**OVP HEALTH CARE, INC.
LAWRENCE COUNTY, OHIO**

FAIRLAND HIGH SCHOOL CLINIC

ADDENDUM #1

THRASHER PROJECT #T60-11686

A6.01

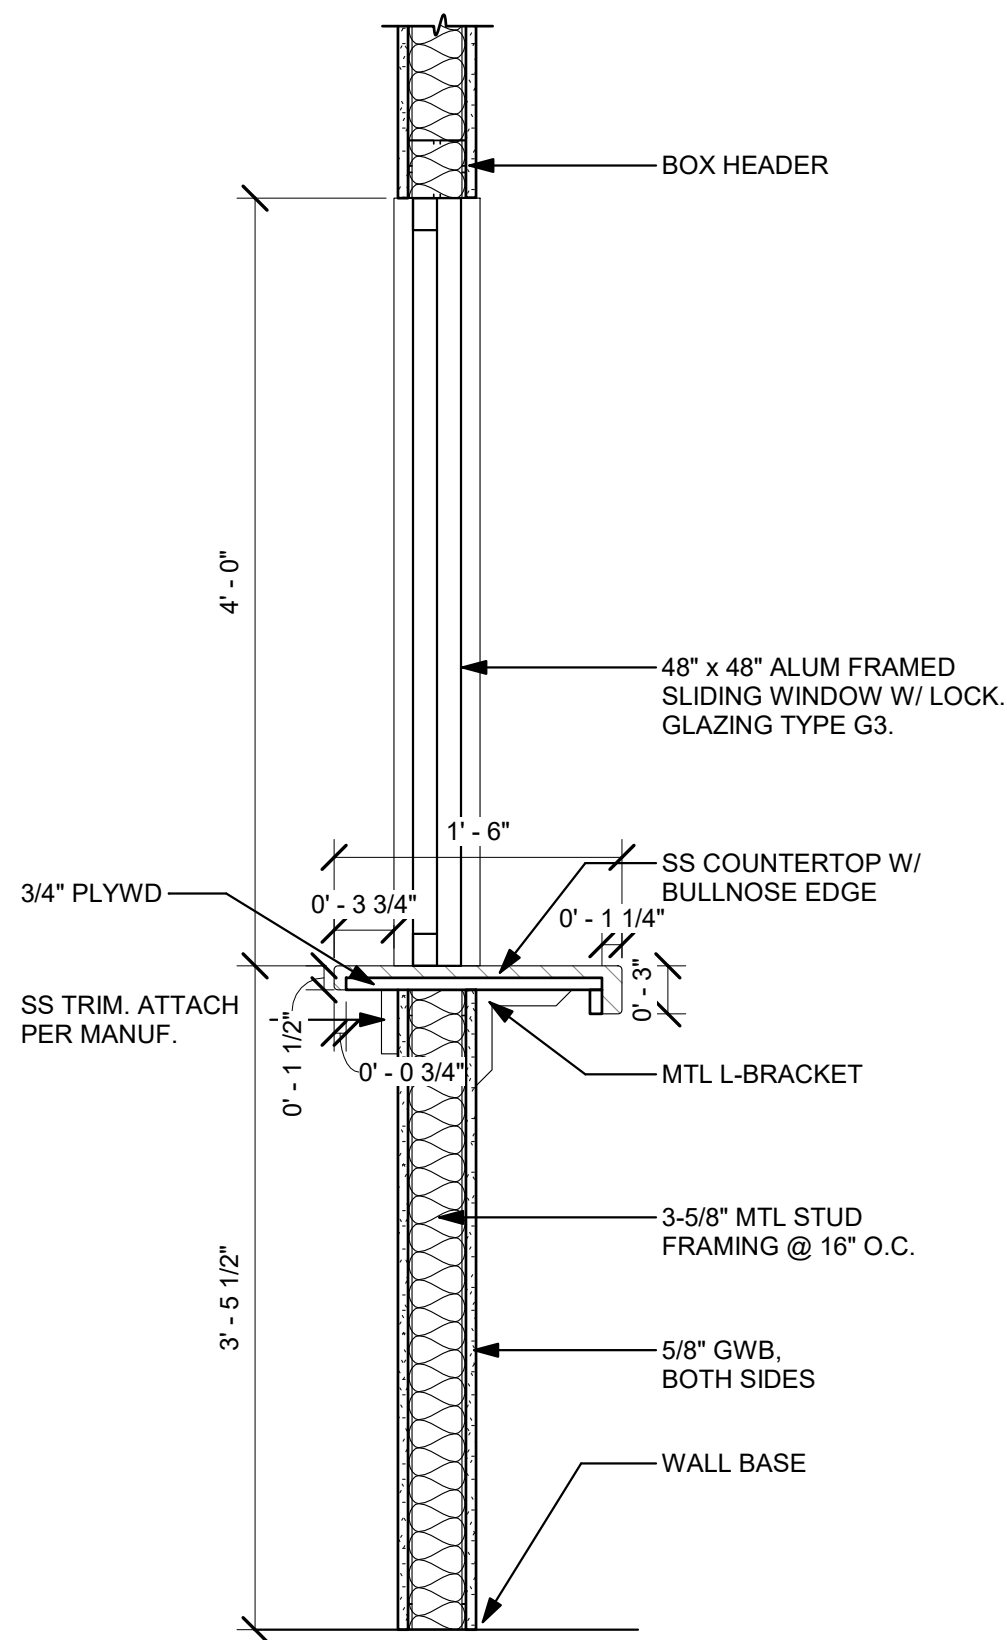
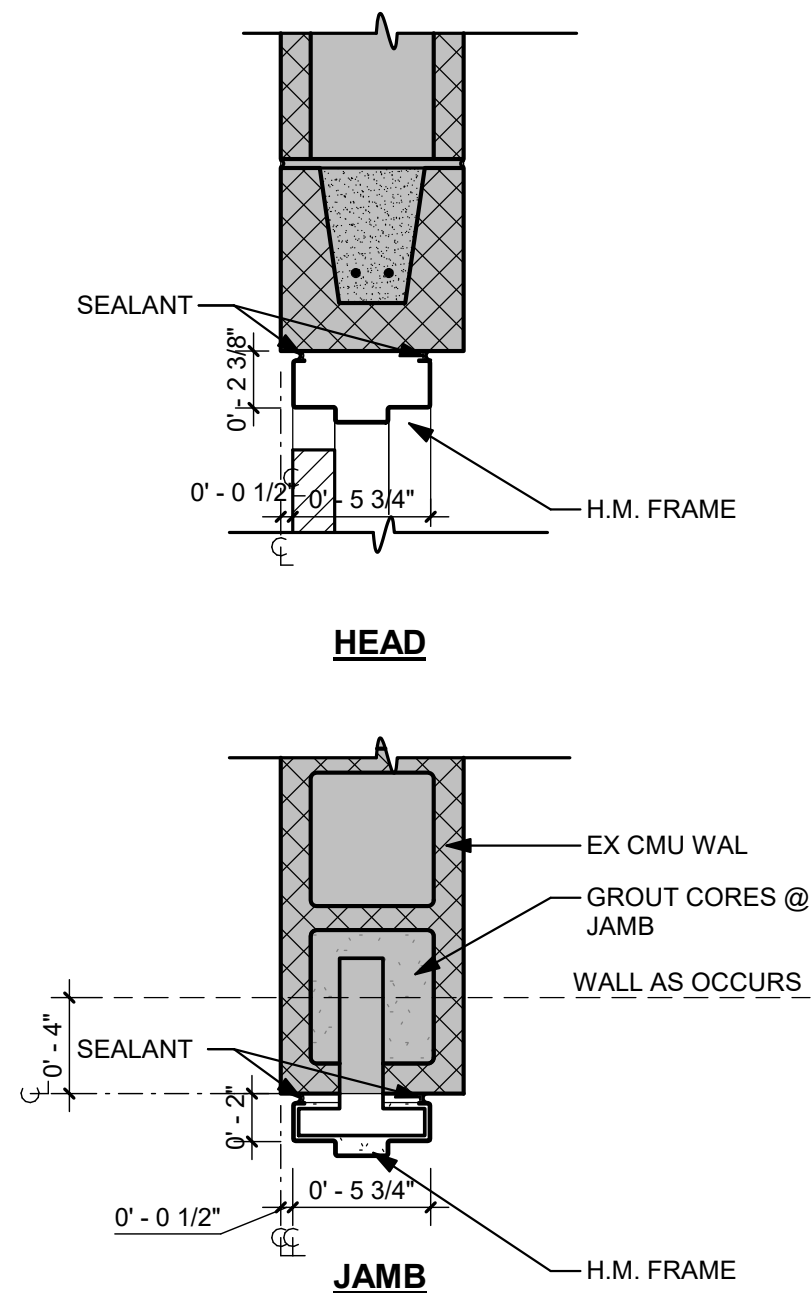
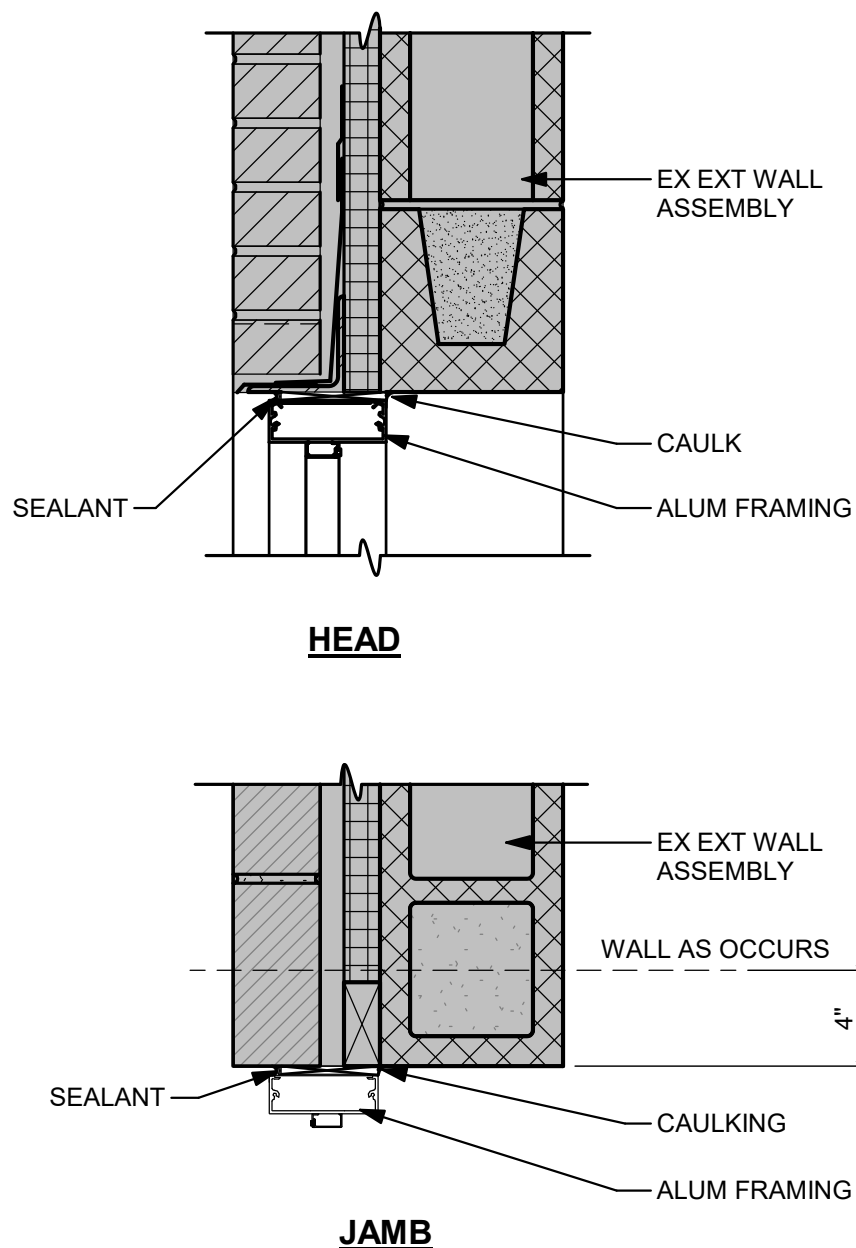
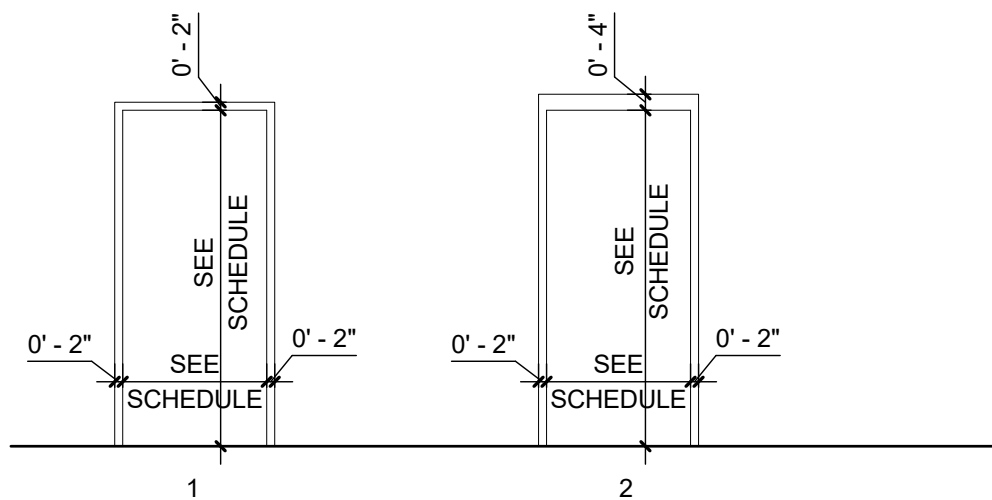
The following has been revised to remove the 2-hr fire barrier:

A6.01 has been revised.
